Docket No. 50-220

Change No. 11  
 License No. DPR-17

CHANGE NO. 11 TO TECHNICAL SPECIFICATIONS

PROPOSED REFUELING WITH 8 x 8 FUEL

FIGURE 2.1.2 REVISED  
 FLOW BIASED SCRAM AND APRM ROD BLOCK

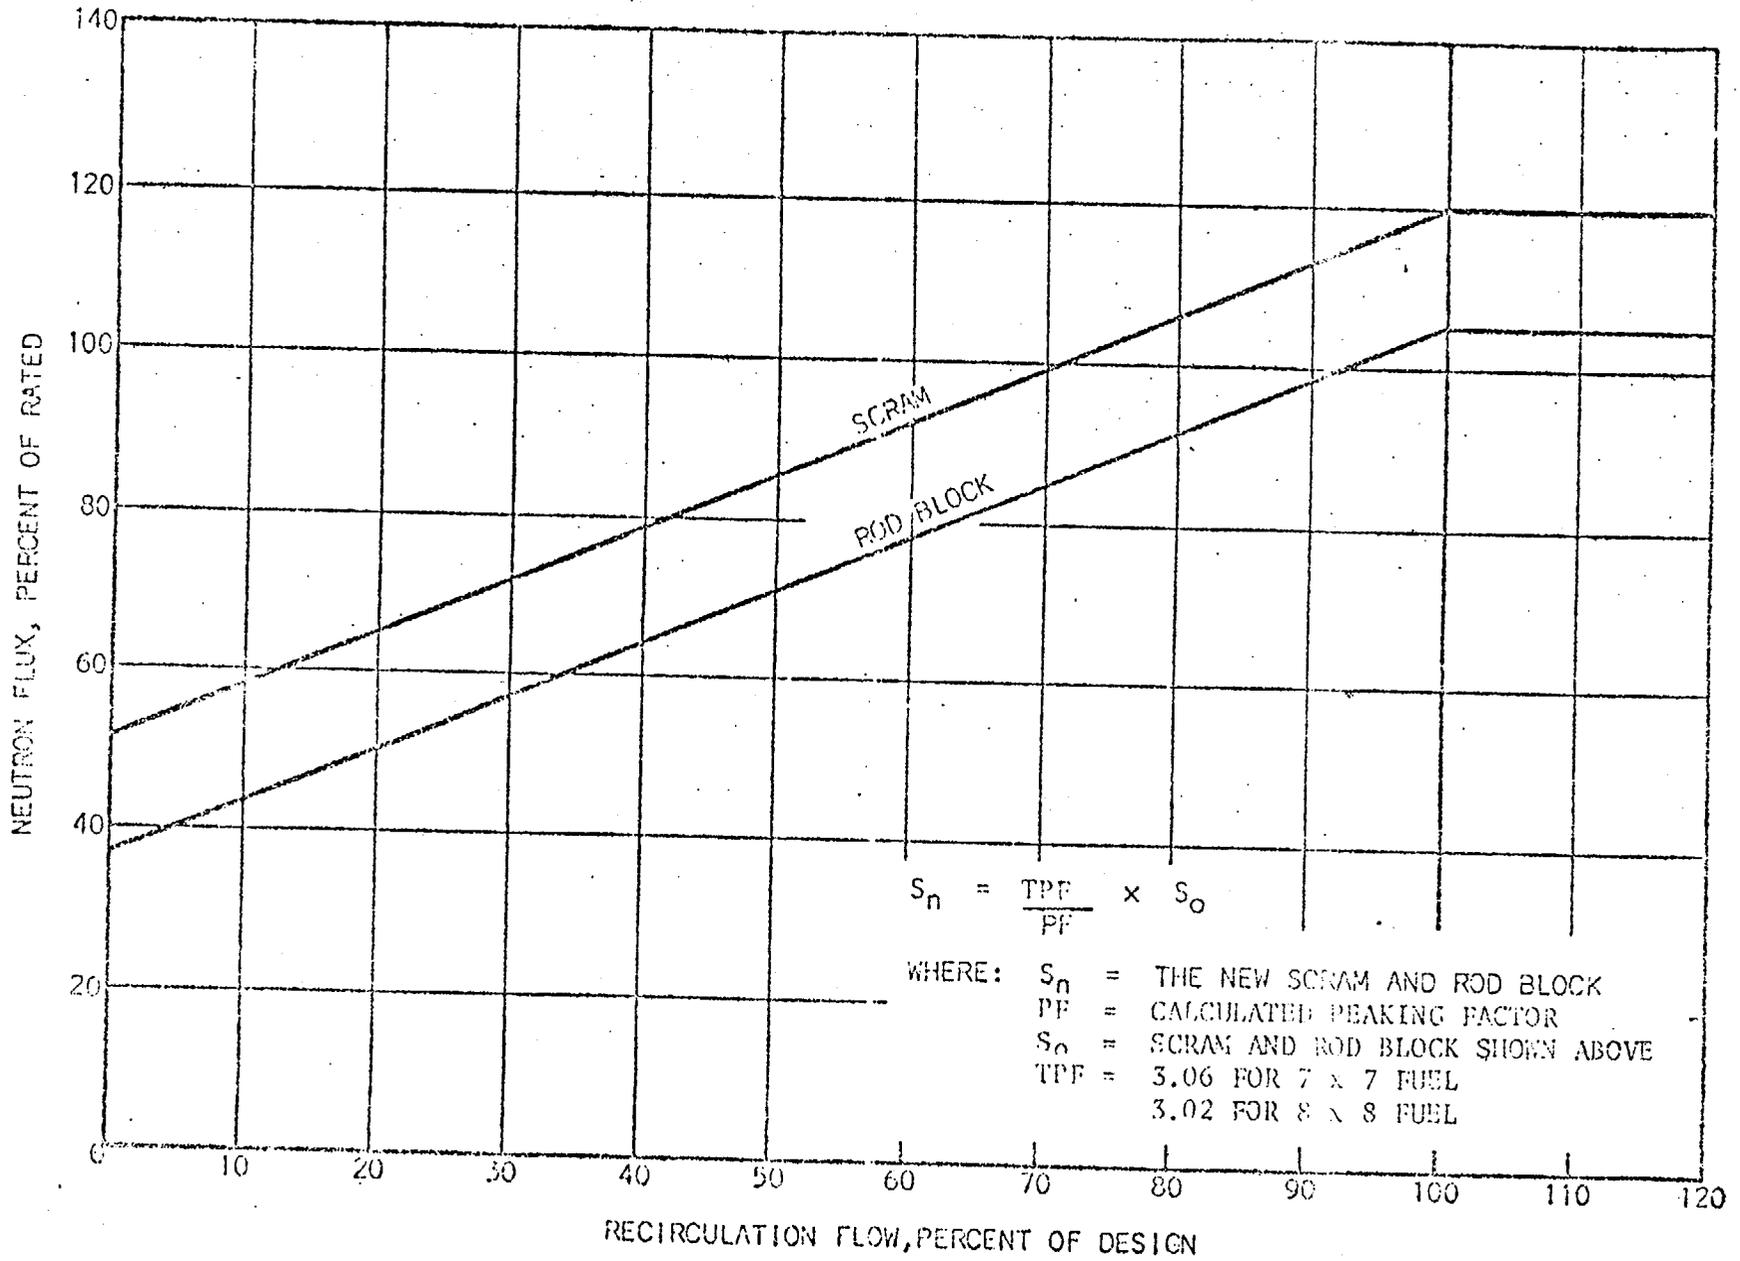
<u>Item</u>	<u>Location</u>	<u>Change</u>
Basis Statement 2.1.1	page 7	Insert the following words after the number 3.06 in lines 3, 10, and 11 of the last paragraph "for 7 x 7 fuel and 3.02 for 8 x 8 fuel".
Safety Limit: Figure 2.1.1 Revised	page 10	Replace the number 3.06 under notes and in the equations with the letters "TPF" and add the following:  "TPF = 3.06 for 7 x 7 fuel 3.02 for 8 x 8 fuel"
Basis Statements for 2.1.2 and 2.1.2.a	page 11	Add a superscript 11 to 6, 7, 9, and 10 on line 4 and on last line of paragraph on page. At bottom of page add as Reference 11, Letter, Philip D. Raymond, Vice President - Engineering, Niagara Mohawk Power Corporation, to A. Giambusso, Deputy Director for Reactor Projects, USAEC, dated October 15, 1973.
Basis Statement for 2.1.2.a	page 12	Replace the first sentence in the last paragraph with the following: "The thermal hydraulic safety limit of Figure 2.1.1 Revised was based on a total peaking factor of 3.06 for 7 x 7 fuel design and 3.02 for 8 x 8 fuel design and an adjustment is required in the unusual event of higher peaking factors".

Basis Statement for 2.1.2.f	page 14	Change the figure on the third line from 106 to 105.

The APRM provides protection of the core in the event of an inadvertent withdrawal of a control rod of high reactivity worth from an assumed control rod pattern which is not normally used, but which maximizes control rod reactivity worth for purposes of the analysis. The APRM rod block provides local protection of the core fuel by limiting control rod withdrawal so that the minimum critical heat flux ratio (MCHFR) is maintained above 1.0. At present, the upscale trip set point of the APRM rod block is specified to be 106 percent of the initial level of APRM channel reading. At this setting, the FSAR analysis showed rod withdrawal being blocked when MCHFR was 1.4. As a result of changes in core characteristics during the previous reloads and with the introduction of 8 x 8 fuel, the reanalysis by Niagara Mohawk shows that the upscale trip set point has to be reduced to provide a MCHFR above 1.0. The proposed change would reduce the trip set point to 105 percent of the initial level of APRM channel reading. At this reduced setting and with the reanalysis, the rod withdrawal is shown to be blocked when MCHFR is about 1.15. Although the margin to a MCHFR of 1.0 is reduced, it is still within the range of approved values for other reactors and provides a margin which we consider acceptable. The proposed setting reduction to a more restrictive value is therefore acceptable.

FIGURE 3.1.7. e MAXIMUM ALLOWABLE AVERAGE PLANAR LHGR  
APPLICABLE TO FUEL TYPE 5 and 6

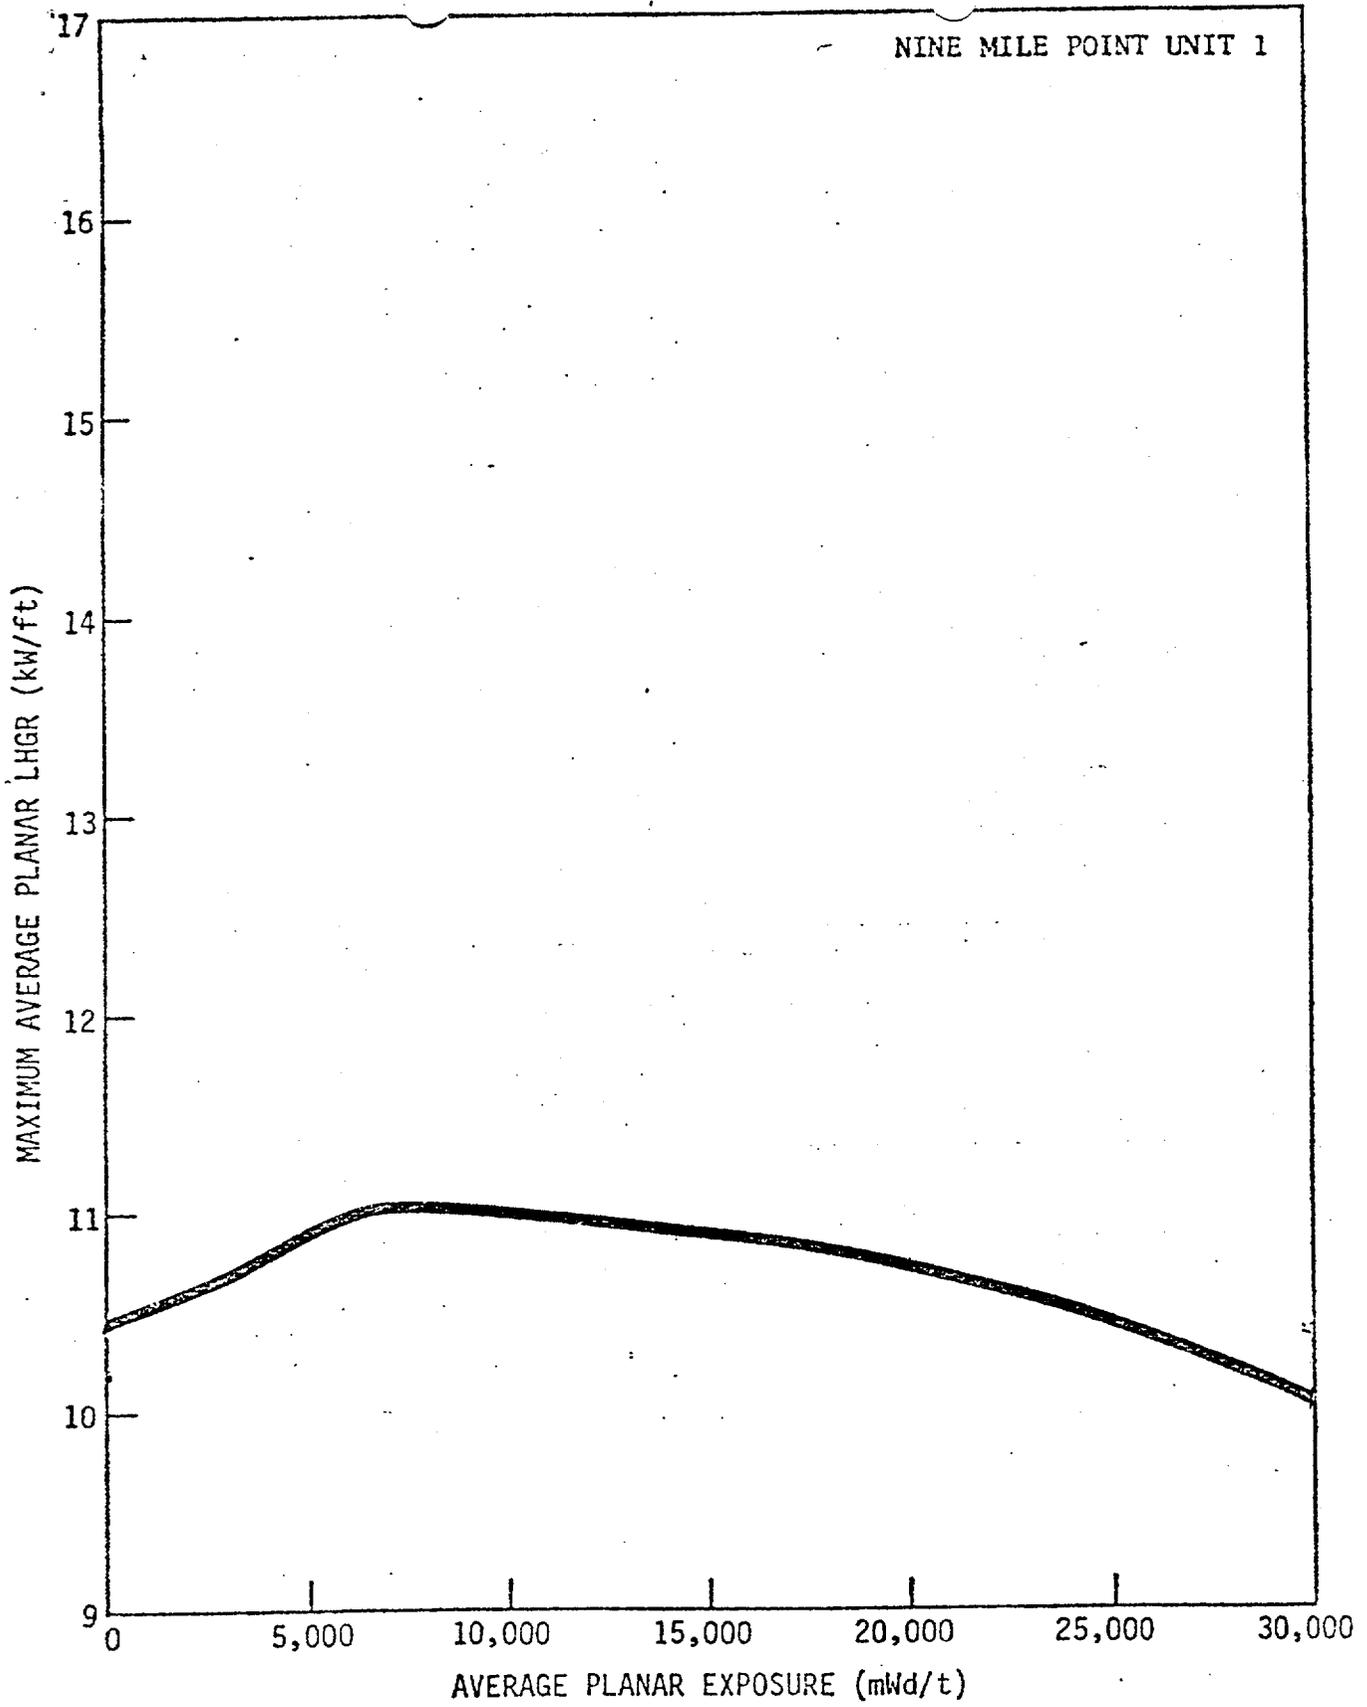
<u>Item</u>	<u>Location</u>	<u>Change</u>
Basis Statement for 2.1.2g-h	page 14	Change the last sentence of the first paragraph by adding as a reference, Letter, Philip D. Raymond, Vice President - Engineering, Niagara Mohawk Power Corporation, to A. Giambusso, Deputy Director for Reactor Projects, USAEC, dated October 15, 1973.
Basis Statement for 2.1.2.i	page 15	In the parenthetical reference add as a reference, Letter, Philip D. Raymond, Vice President - Engineering, Niagara Mohawk Power Corporation, to A. Giambusso, Deputy Director for Reactor Projects, USAEC, dated October 15, 1973.
Limiting Safety System Setting: Figure 2.1.2 Revised	page 16	Replace Figure 2.1.2 Revised with the attached Figure 2.1.2 Revised.
Limiting Condition for Operation 3.1.7.a	page 37a	Add the attached Figure 3.1.7e to the Technical Specification. Under the Limiting Condition for Operation 3.1.7.a, add Figure 3.1.7e to the list of figures at the end of the last sentence in paragraph a.

Limiting Condition for Operation 3.1.7.b	page 37a	Replace the notes to the equation in Limiting Condition for Operation 3.1.7.b with the following:  "LHGR = Design LHGR = 17.5 kW/ft for 7 x 7 fuel or 13.4 kW/ft for 8 x 8 fuel  (Delta p/p) <sub>MAX</sub> = Maximum power spiking penalty = 0.040 for 7 x 7 fuel or 0.027 for 8 x 8 fuel.  LT = Total Core length = 12 ft. L = Axial position above bottom of core"
Basis Statement for 3.1.7.a	page 37a	Add Figure 3.1.7.e to the list of figures in the third paragraph of the Bases 3.1.7.a.

Average planar and local LHGR is a function of the fuel type and is related to fuel densification. Since a new fuel type (the 8 x 8) is being added to the core, new limitations must be incorporated in the Technical Specifications. By letter dated January 22, 1974, the applicant provided proposed maximum average planar LHGR limits applicable to the 8 x 8 fuel. The applicant used the present approved fuel rod thermal performance model, GEGAP-III<sup>(3)(4)</sup>, as the basis for the MAPLHGR limits. The cladding collapse model and power spike model used in the applicant's analysis are consistent with the previous basis<sup>(3)(4)</sup>. Therefore, the proposed technical specifications for MAPLHGR and local LHGR, calculated by use of the approved fuel densification model, are acceptable.

Figure 1. Design Reference Core Loading

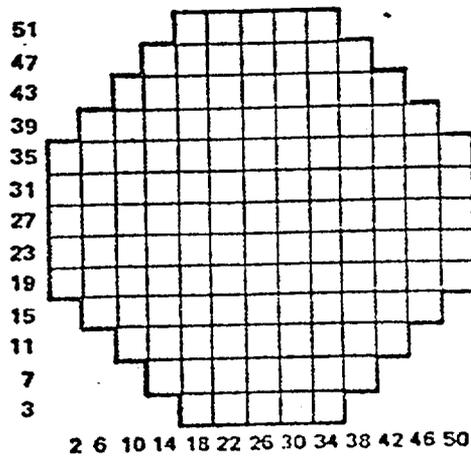
The 8 x 8 reload fuel has been designed to be compatible with and closely match the mechanical, nuclear, and thermal-hydraulic characteristics of the NMP-1 initial core and the previous reload 7 x 7 fuel. The reference core is based on a scatter pattern of reloading the 8 x 8 fuel as shown by Figure 1. No significant fuel loading asymmetries will exist. As shown, the reloading is in a one-in-four arrangement involving either a Type 5 or Type 6 fuel assembly. The only difference between a Type 5 and Type 6 fuel assembly is the enrichment with Type 5 containing an average enrichment of 2.62 weight percent of U-235 and Type 6 containing 2.50 weight percent of U-235. These fuel types and loading fall within the scope of the staff report<sup>(1)</sup> on the 8 x 8 fuel assembly. The thermal-hydraulic limiting conditions of operation and the response of the coolant circulation system is consistent with that used in the staff report. The methods of analysis used by the licensee are identical to the methods approved by the staff. Therefore, the evaluations and conclusions of the staff report with respect to normal operations, abnormal operational transients, and accidents are fully applicable to NMP-1.
